PLANNING AND DEVELOPMENT SERVICES STAFF REPORT

For Planning Commission Meeting of July 12, 2016

SUBJECT: New Farmers Market Enclosure Site Plan and Landscape Modification for City Council Approval (315 Detroit Street) File No. SP16-075

SHEET SP1 OF 2

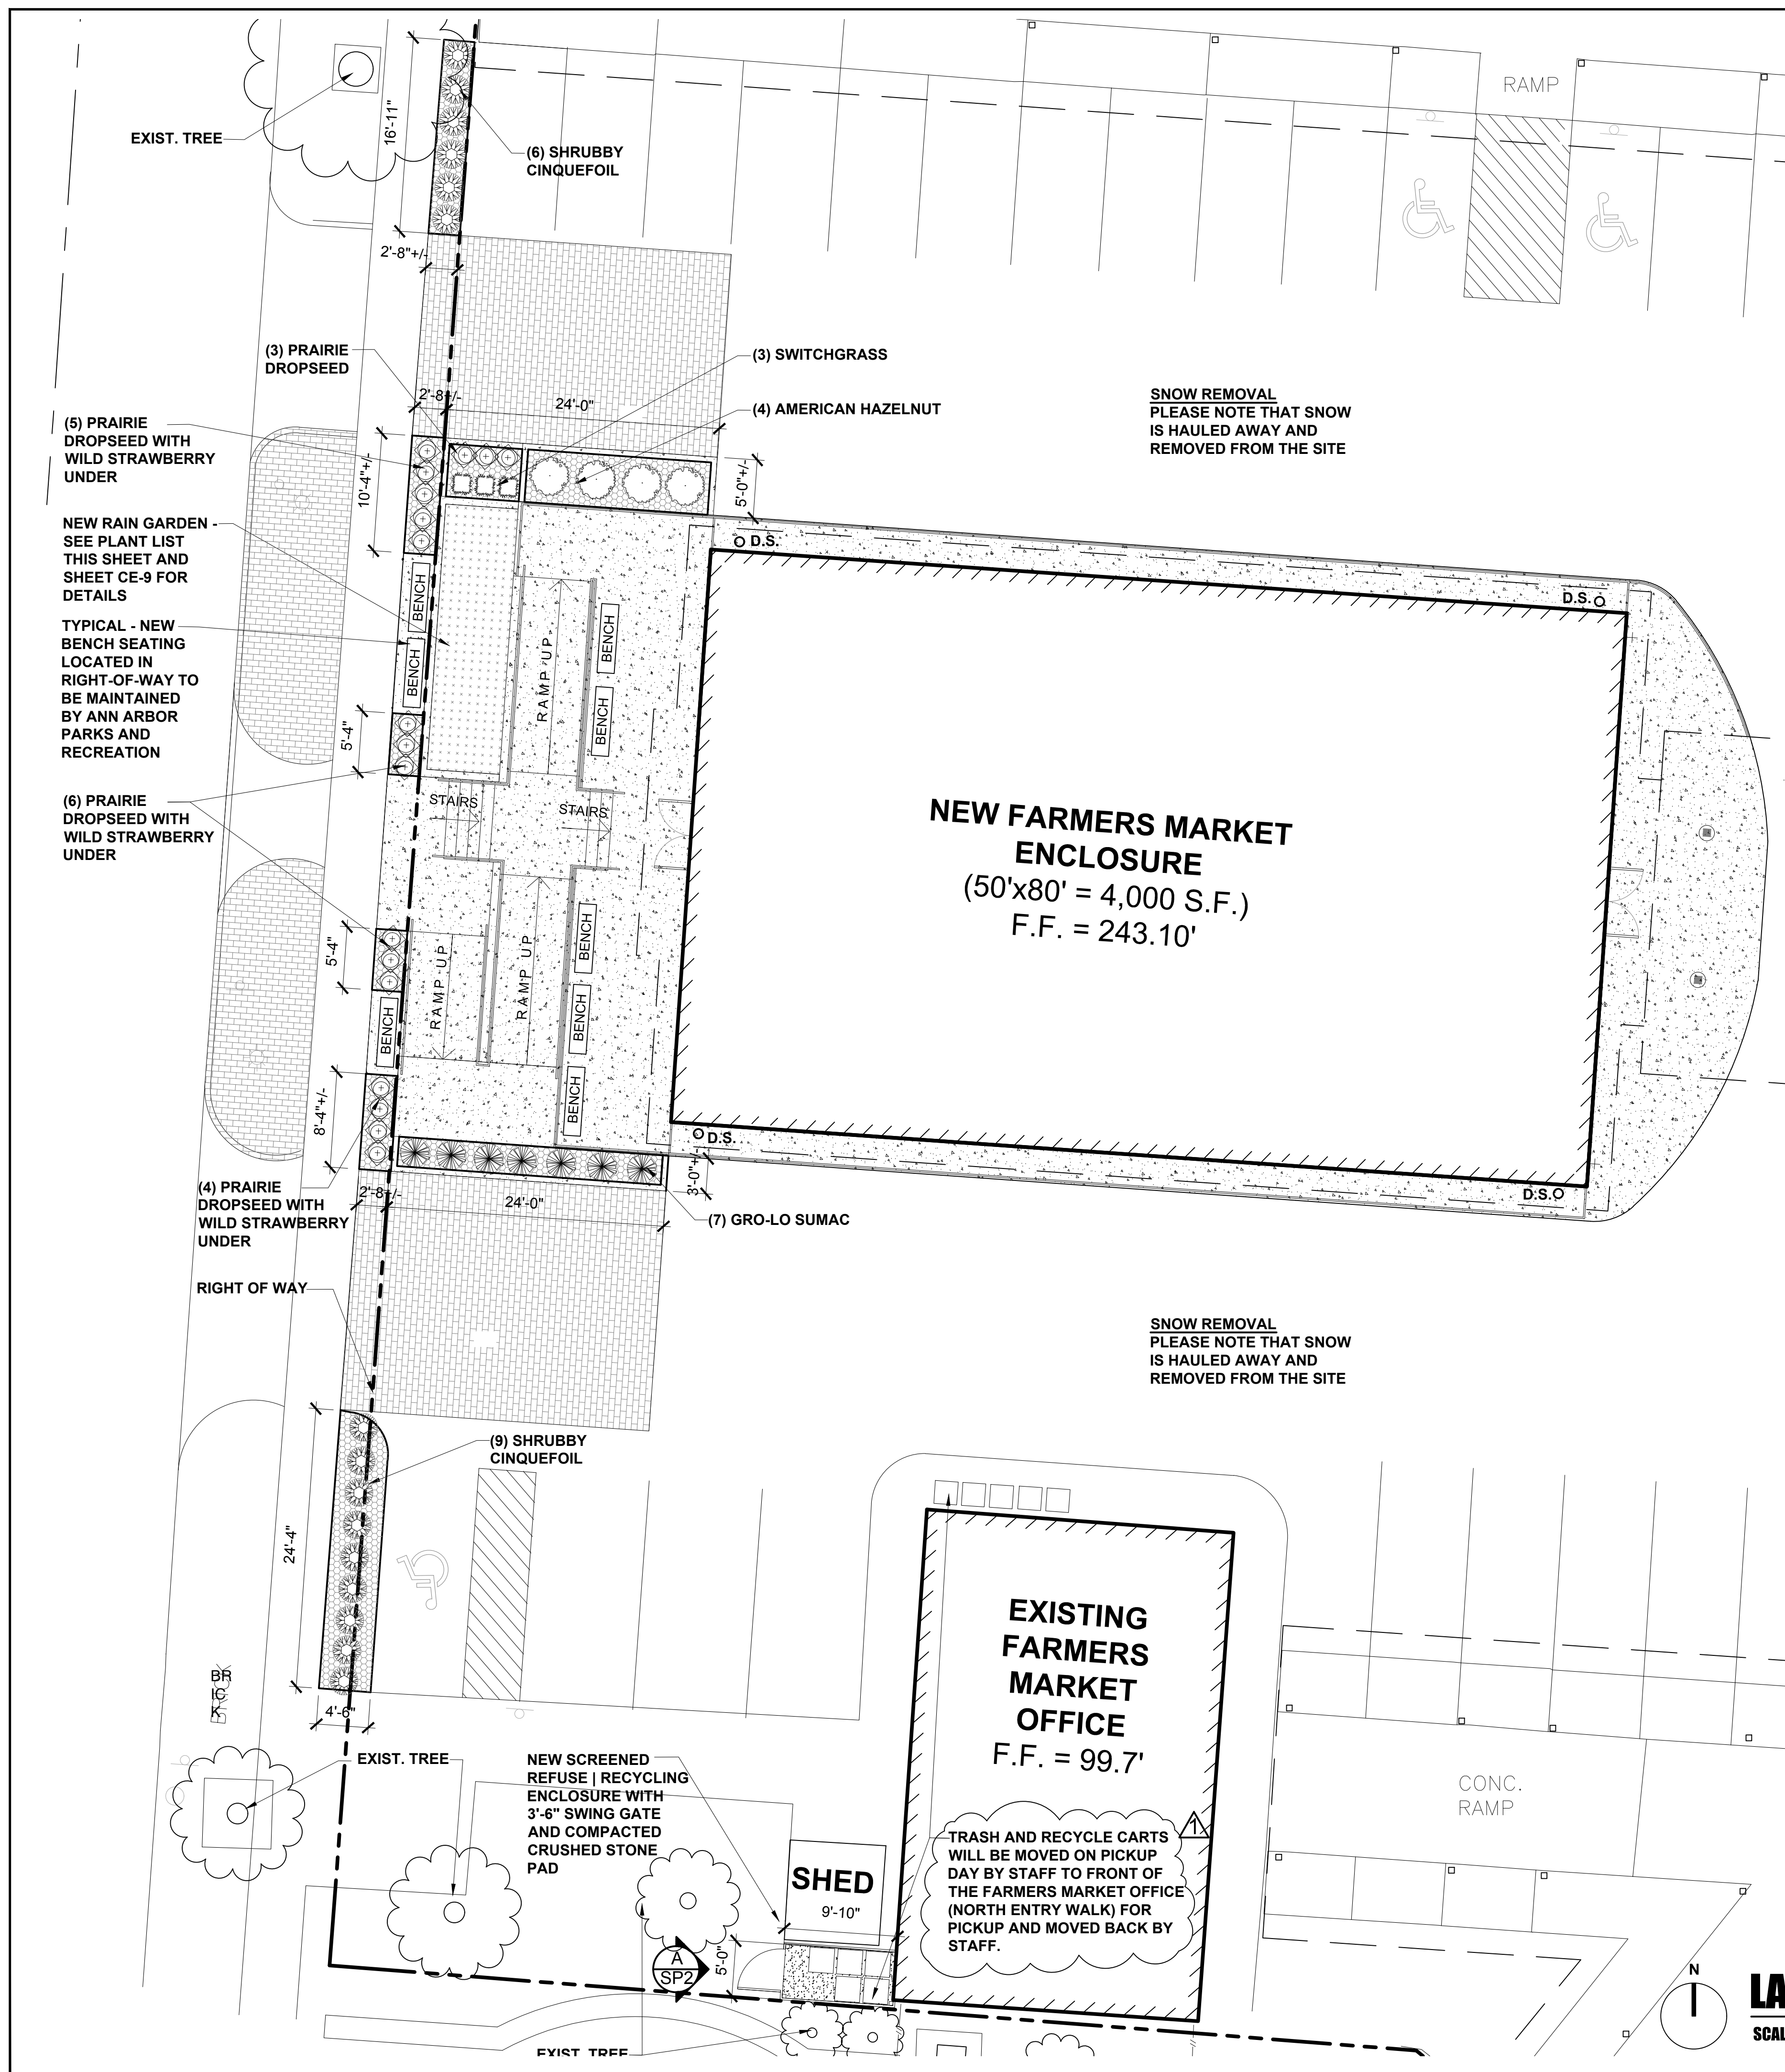
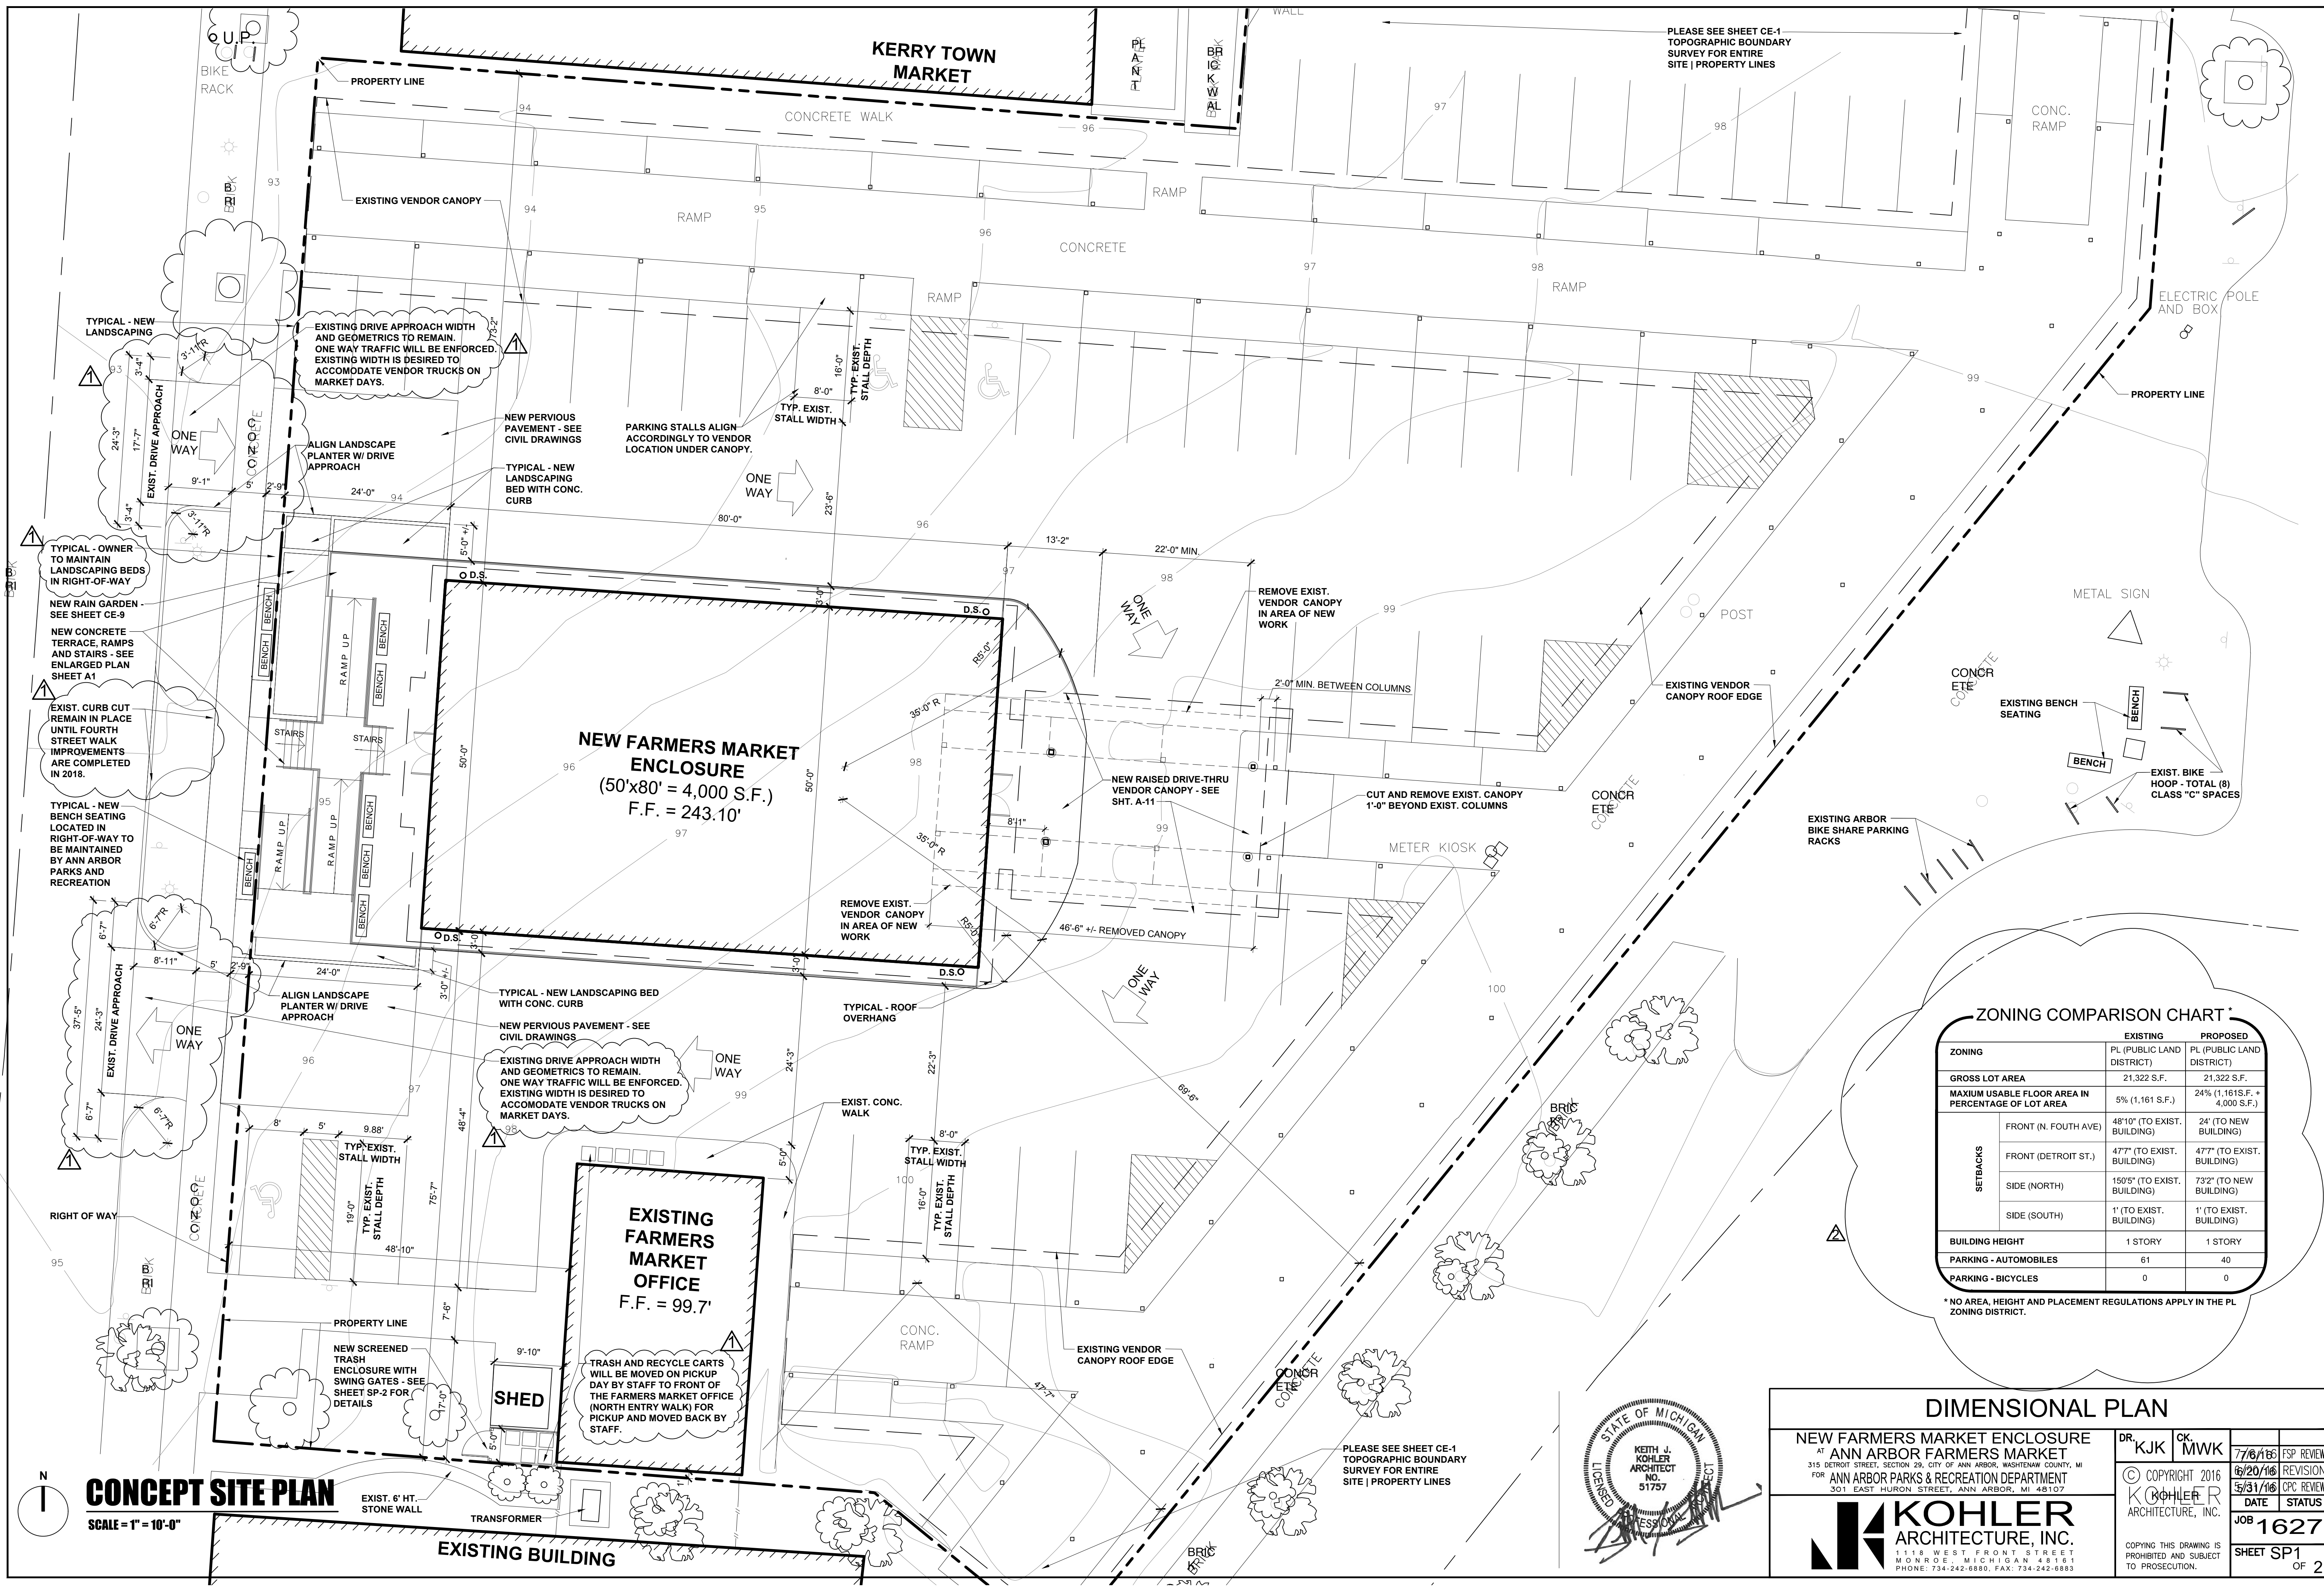
- The proposed driveway width of up to 24'3" exceeds the fifteen to twenty foot width allowed for one-way drives (Chapter 47, Section 4:20(4)(c))
- Useless curb cuts must be eliminated (Chapter 47, Section 4:20(8)).

Public Services, Engineering – Two items do not comply with City Code: The proposed driveway width of up to 24’3” exceeds the fifteen to twenty foot width allowed for one-way drives (Chapter 47, Section 4:20(4)(c)); also, useless curb cuts must be eliminated (Chapter 47, Section 4:20(8)). Notes on the plan indicate that maintaining the existing drive width is desired to accommodate vendor trucks on market days, and the useless curb cut on North Fourth Avenue will remain in place until sidewalk improvements, scheduled for 2018, are completed by the city.

EXISTING DRIVE APPROACH WIDTH
AND GEOMETRICS TO REMAIN.
ONE WAY TRAFFIC WILL BE ENFORCED.
EXISTING WIDTH IS DESIRED TO
ACCOMMODATE VENDOR TRUCKS ON
MARKET DAYS.

EXISTING DRIVE APPROACH WIDTH
AND GEOMETRICS TO REMAIN.
ONE WAY TRAFFIC WILL BE ENFORCED.
EXISTING WIDTH IS DESIRED TO
ACCOMMODATE VENDOR TRUCKS ON
MARKET DAYS.
